REGIONAL REVIEW NOTIFICATION

Name of Proposal: Highway 74 Business Tech Park DRI 3628

<u>Description</u>: A DRI review of a proposal to construct 733,882 SF of warehouse distribution facility space in five buildings on a 61 acre site off of SR 74/Joel Cowan Parkway at Jenkins Road in the Town of Tyrone in Fayette County.

PRELIMINARY COMMENTS:

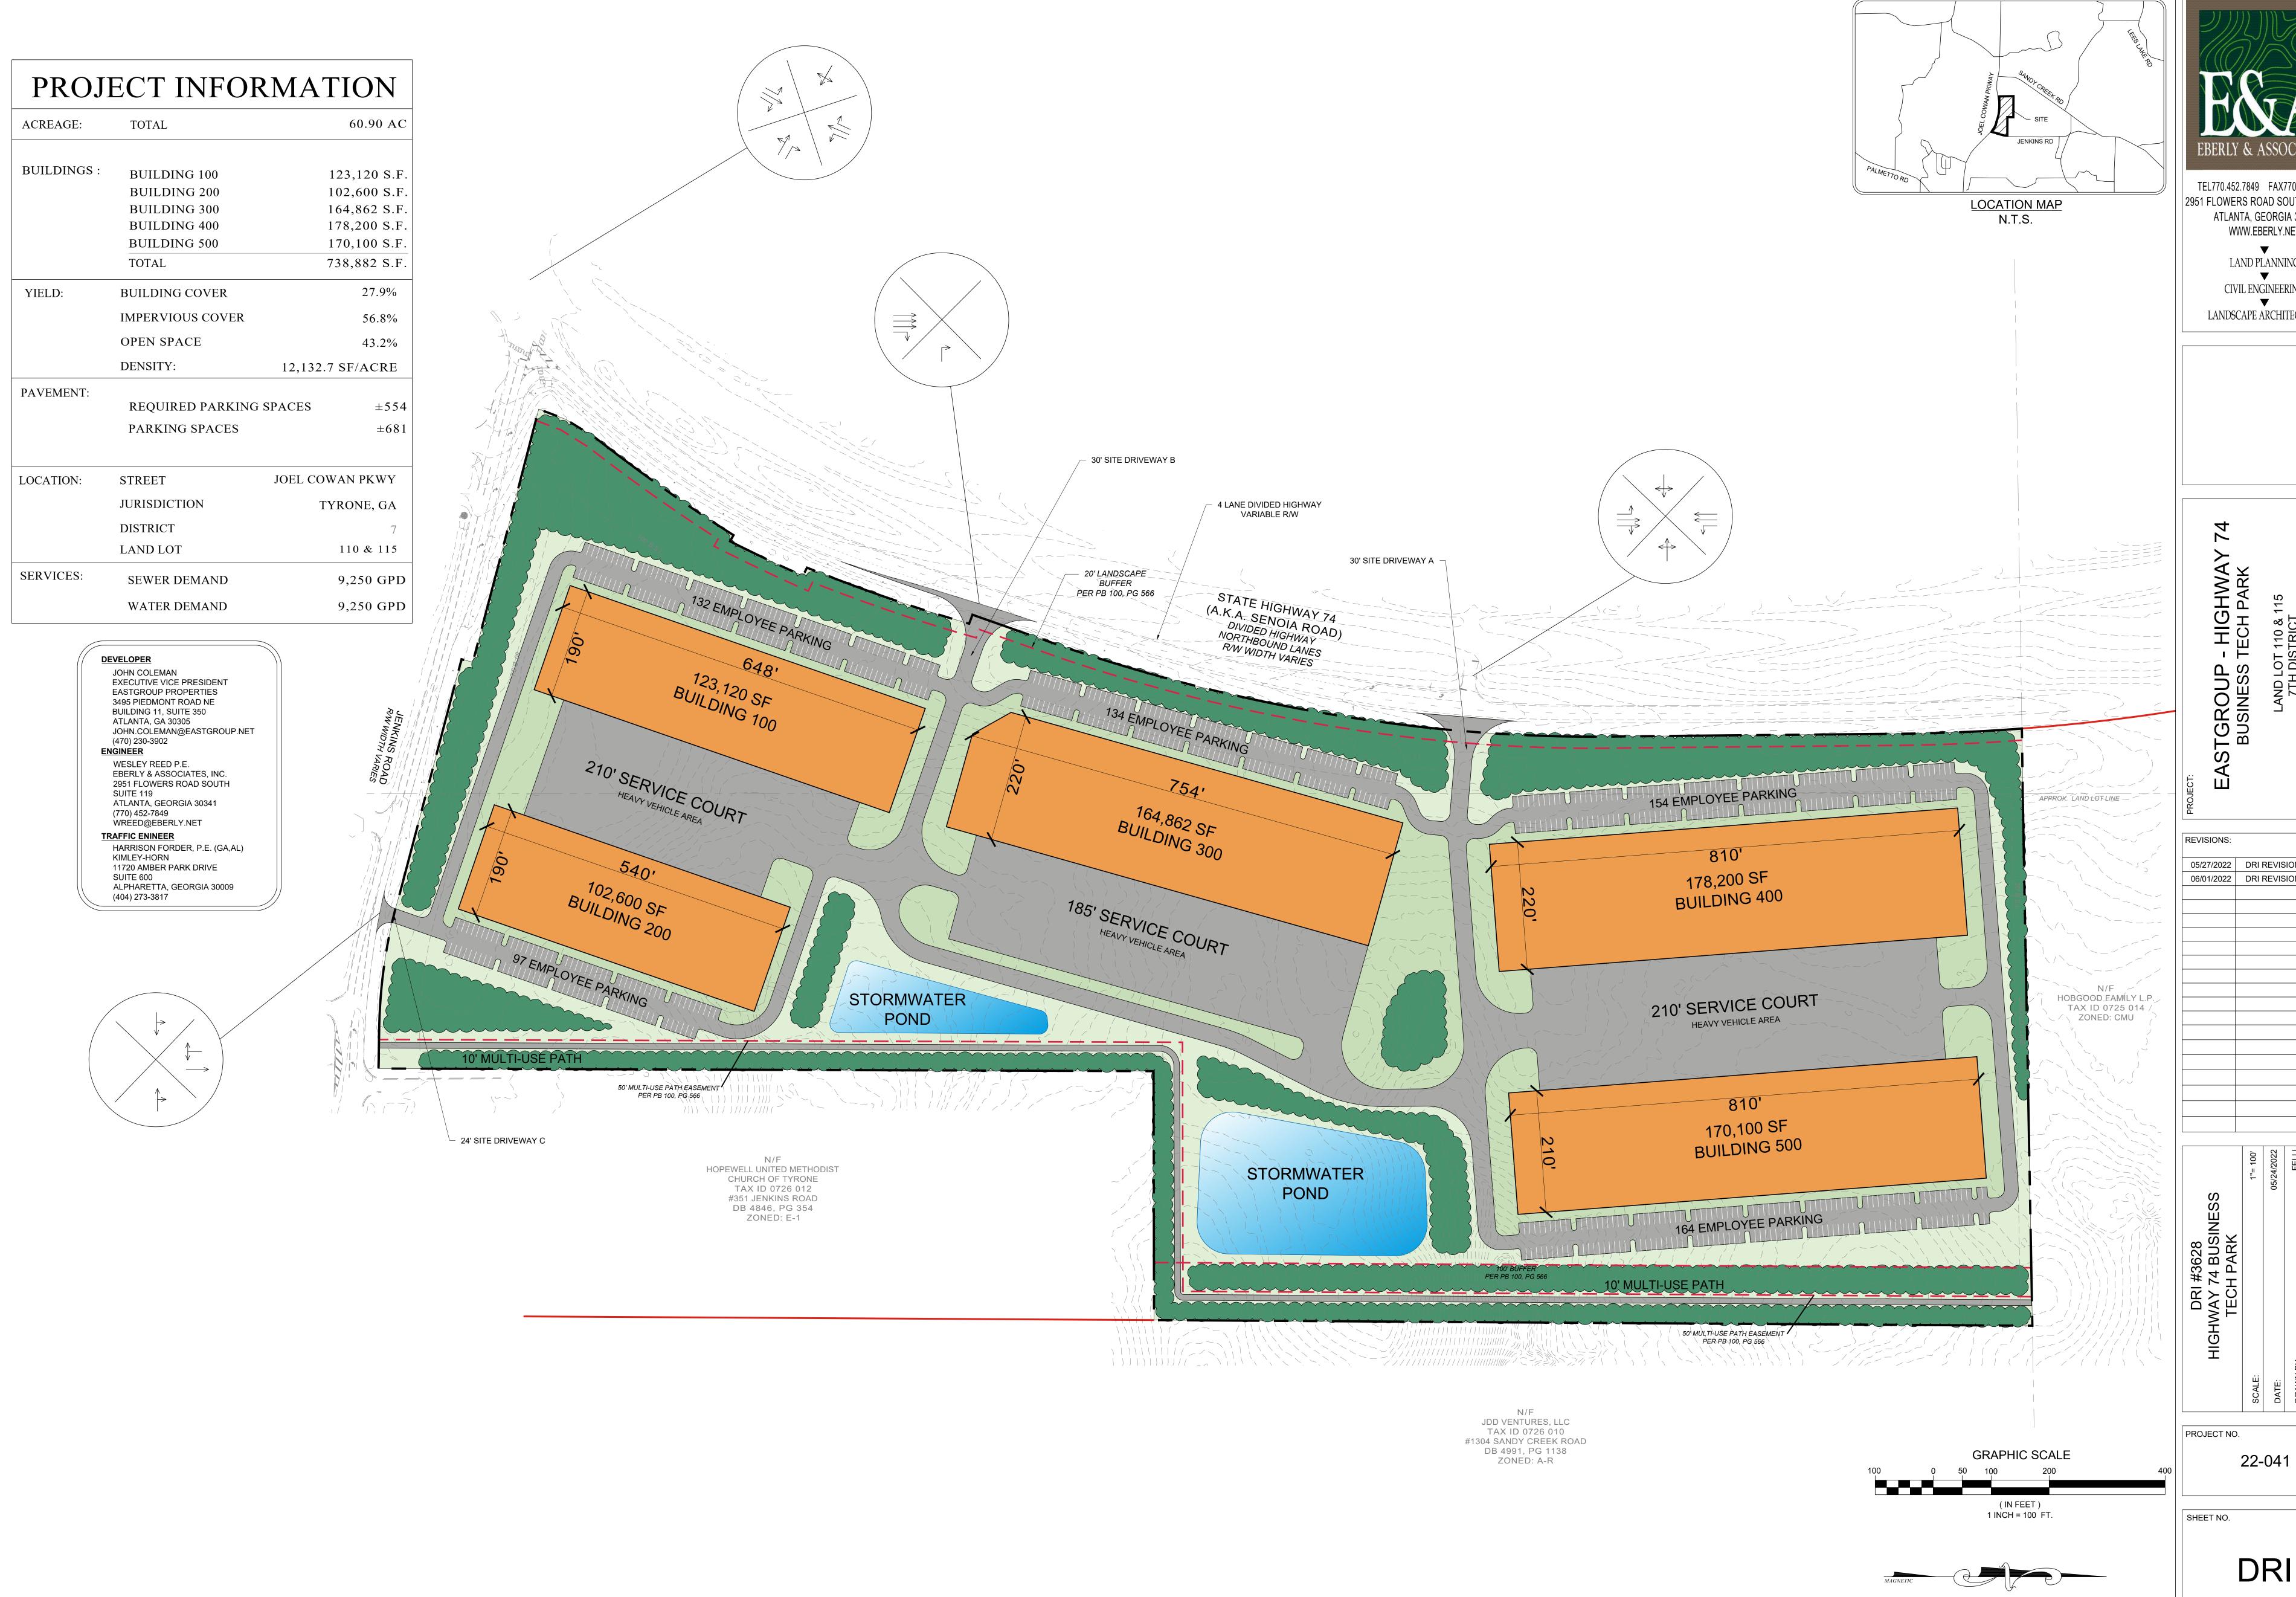
The headwaters of a mapped stream may be located in the area of the southern stormwater pond; if so a stream buffer variance may be required.

No sidewalks are shown on the site plan but the TIS states that sidewalks will be provided between buildings. A multi-use trail is proposed on the east side of the project that will connect to Peachtree City; careful alignment of the trail with connecting segments to the north and south will be key to making it viable.

Incorporation of green stormwater and heat island mitigation designs for the roughly 681 surface car parking spaces proposed would be supportive of regional environmental policies.

A total of 681 parking spaces are provided; no EV charging stations appear to be proposed. Provision of some EV charging spaces would be supportive of regional EV infrastructure goals.

No sidewalks are shown on the site plan. Sidewalks between buildings connecting to a future external sidewalk system or transit opportunities are considered a minimum component of a multi-modal transportation strategy. The proposed multi-use trail on the east side of the project is a positive feature but it will need to be integrated with connecting segments to the north and south to ensure its viability. Care should be taken to ensure that the constructed development provides an interconnected, functional, clearly marked and comfortable pedestrian experience on all driveways, paths, entrances, and parking areas. To the maximum extent possible, new driveways and intersection corners where pedestrians will cross should be constructed with minimal curb radii to reduce speeds of turning vehicles and decrease crossing distances for pedestrians.

The project can better support The Atlanta Region's Plan in general by incorporating other aspects of regional policy, including green infrastructure and/or low-impact design, e.g., pervious pavers, rain gardens, vegetated swales, etc., in parking areas and site driveways, and as part of any improvements to site frontages.

The intensity and land use of the project is not well aligned with the Atlanta Region's Plan recommendations for Developing Suburbs. The project could be made more responsive to these goals and policies by retaining additional undisturbed area, minimizing stream buffer intrusions, and dedicating undisturbed areas for conservation purposes. Town of Tyrone leadership and staff, along with the applicant team, should collaborate closely to ensure optimal sensitivity to the needs of nearby local governments, neighborhoods, and natural systems.
